**UNITED STATES DEPARTMENT OF COMMERCE
Patent and Trademark Office**

09/437,296 11/09/99 YAMAJI

Office Action Summary

DETAILED ACTION

Claim 1 is rejected under 35 U.S.C. 103(a) as being unpatentable over US patent 6145888, Ohmi et al in view of US patent 6039319, Coonce et al. In figure 1 below,

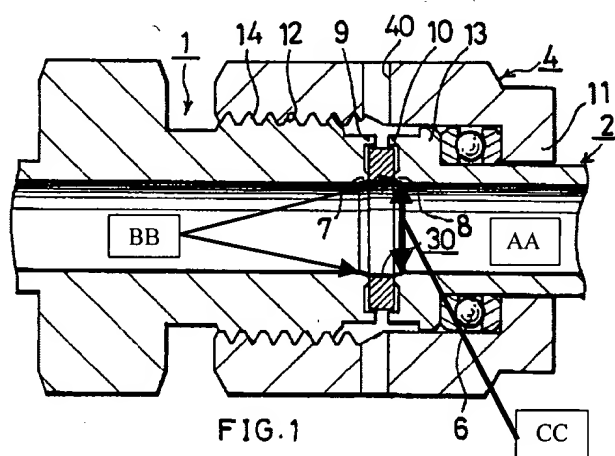
Ohmi et al discloses a fluid

coupling comprising first and second coupling members (1, 2) having respective gasket holding annular ridges (7, 8) on butting end faces thereof, and an annular gasket (30) interposed between the two coupling members, the fluid coupling being characterized in that at least has a fluid channel (AA) comprising an opening passageway (CC) orthogonal to the butting end face thereof, and a slanting main passageway (BB) communicating therewith, the opening passageway having a diameter equal to the inside diameter of the annular ridge. Ohmi et al does not disclose the gasket having an

inside diameter smaller than the diameter of the opening passageway. Coonce et al teaches a gasket (38) having an inside diameter smaller than the diameter of the opening passageway (D1, D2) "to reduce fluid entrapment" (column 4, lines 66-67). It would have been obvious to one having ordinary skill in the art at the time the invention was made to fabricate the gasket with an inside diameter smaller than the diameter of the opening passageway to reduce fluid entrapment, as taught by Coonce et al.
